**28 Compayne Gardens
London, NW6 3DL**

**Basement Impact Assessment
Audit**

London Borough of Camden

Project Number: 12066-84
Revision: F1

BASEMENT / GARDEN PLAN
 SHOWING FOUNDATIONS AND UNDERPINNING.

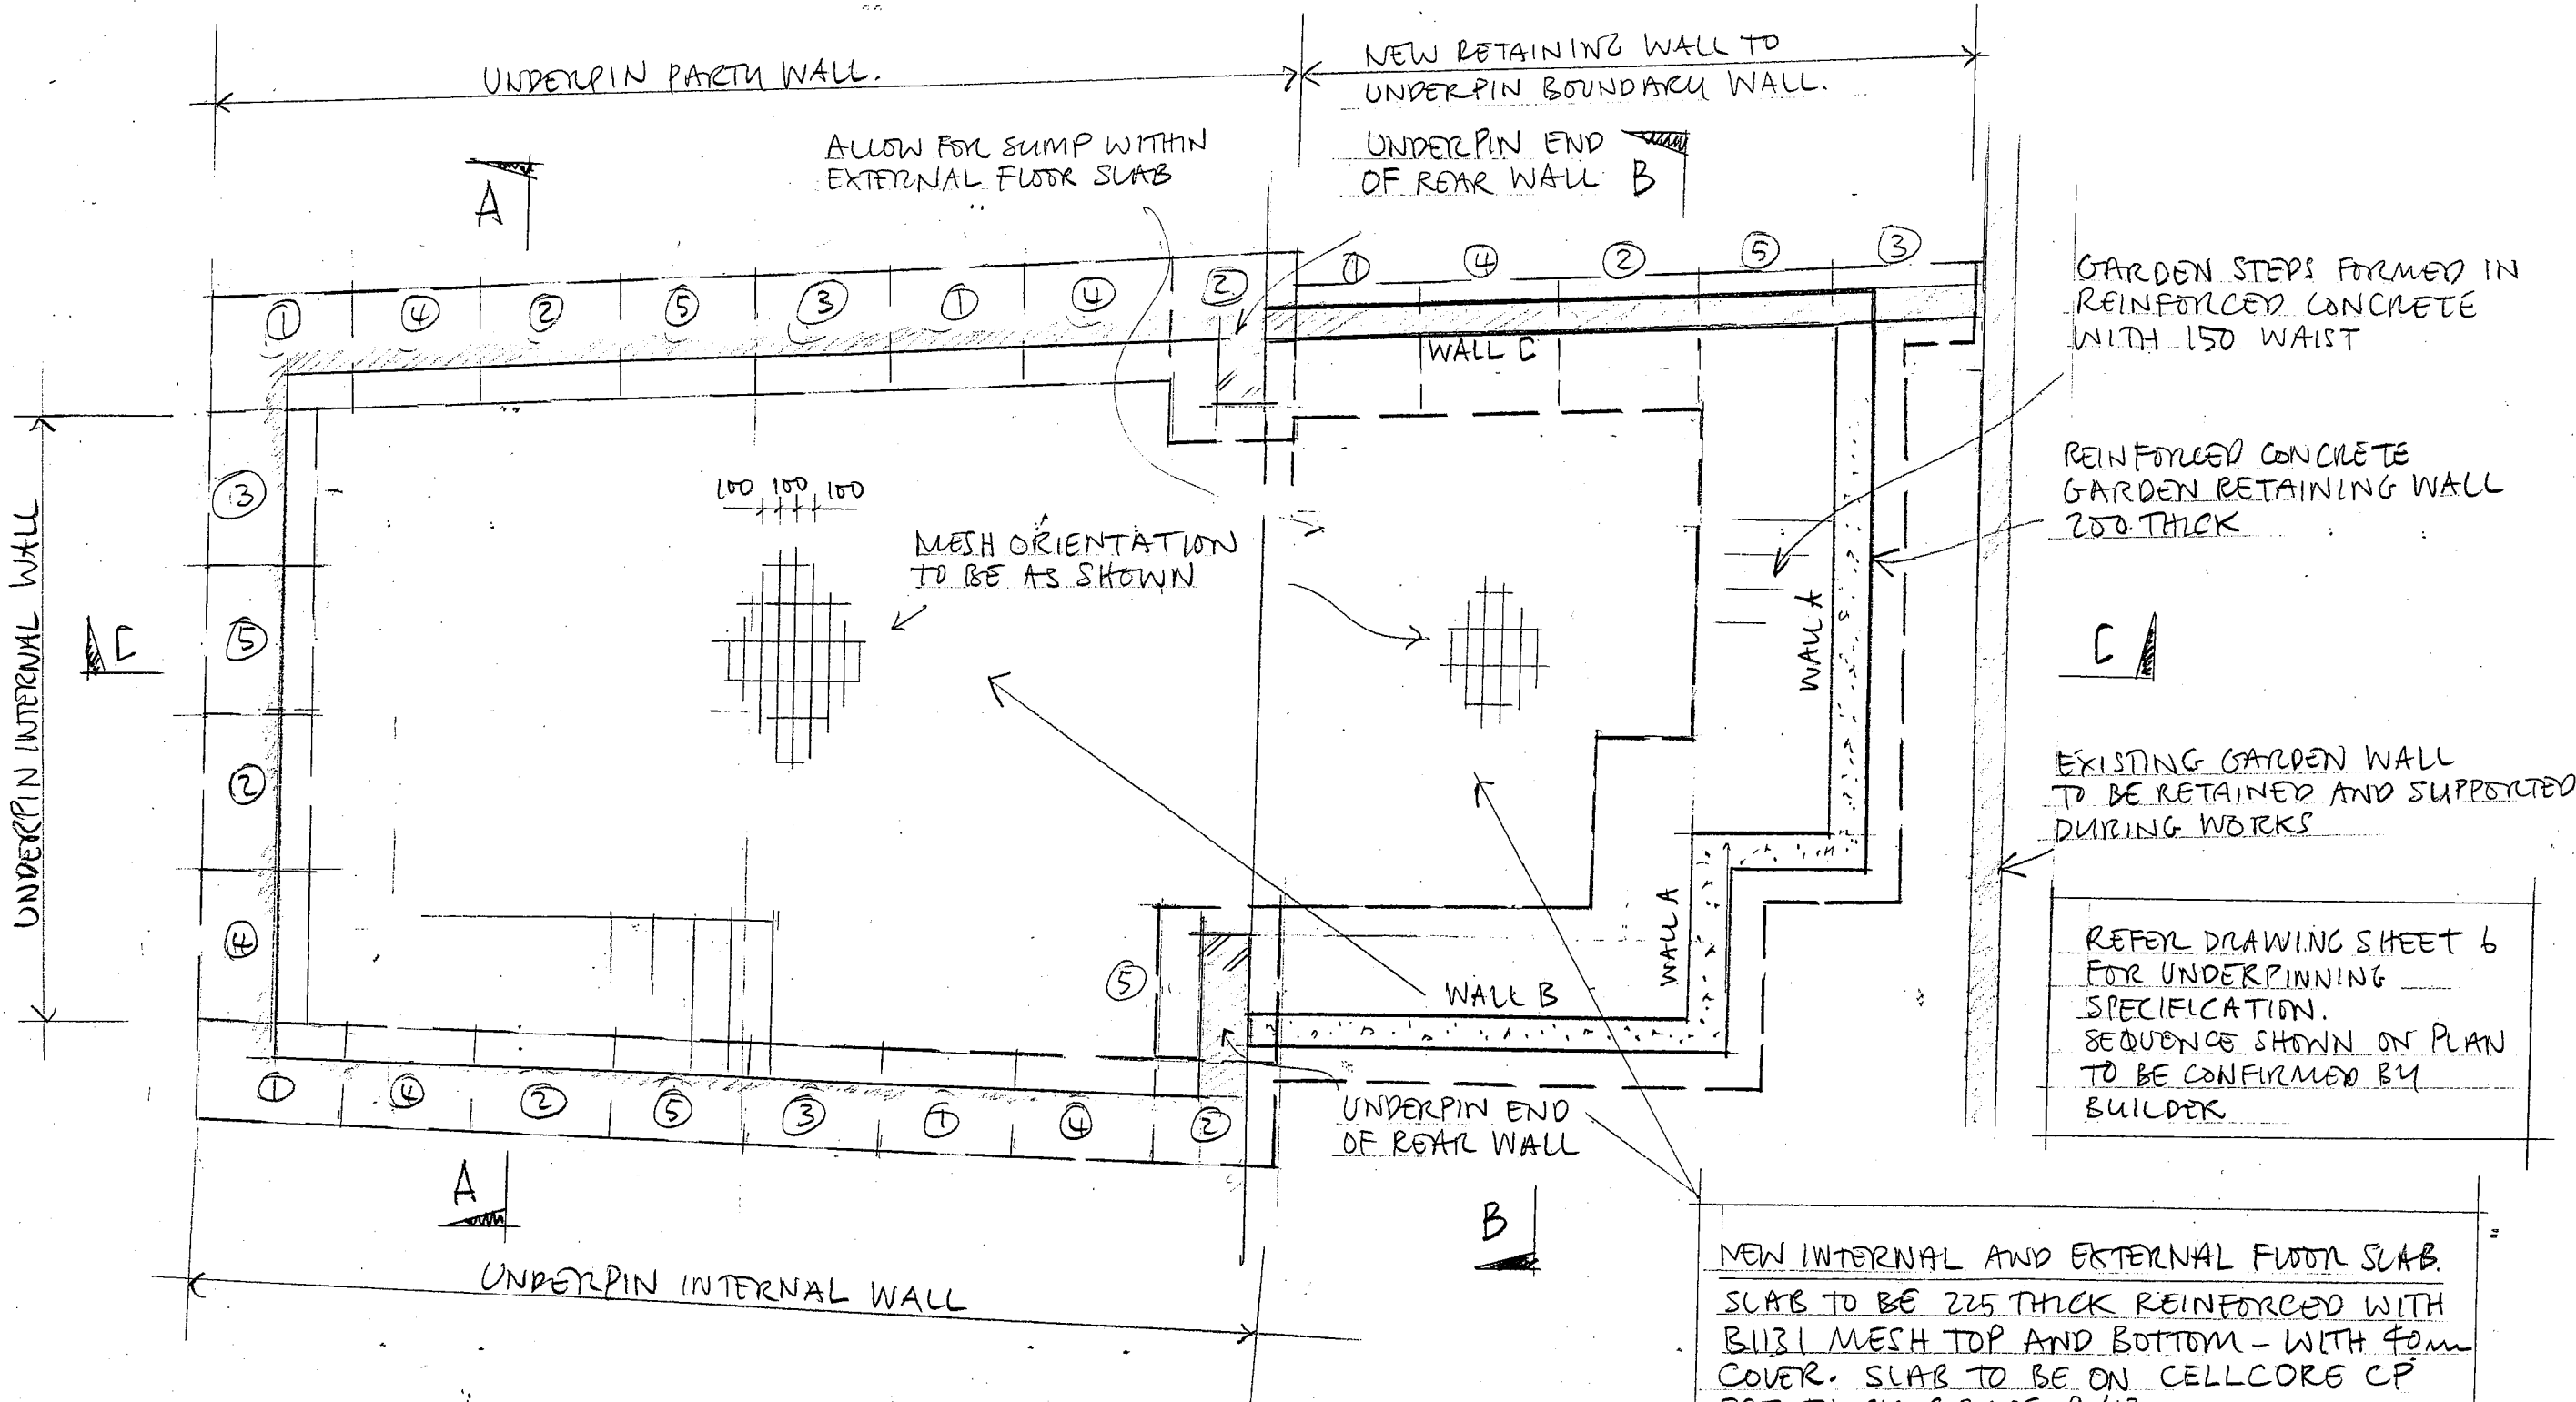
- 4.9. It is also proposed to underpin the existing boundary wall. Structural drawings have now been provided as requested following the initial audit and these indicate a reinforced concrete underpinning which is considered an acceptable solution.

- 5.4. Underpinning is proposed to the rear boundary wall and a structural drawing has been provided to indicate that this will be reinforced concrete which is considered an acceptable solution.

The engineer's plans I sent before (attached again) show the hit and miss sequencing for pins. The underpinning works should take around 7 weeks, with the full works taking 25 weeks (including fit out and decorations). A full construction programme would normally only be available once a contractor is appointed after the planning decision, but if necessary now I'll see if I can get this drafted earlier.

REV A 16/12/15. WALL C REVISED
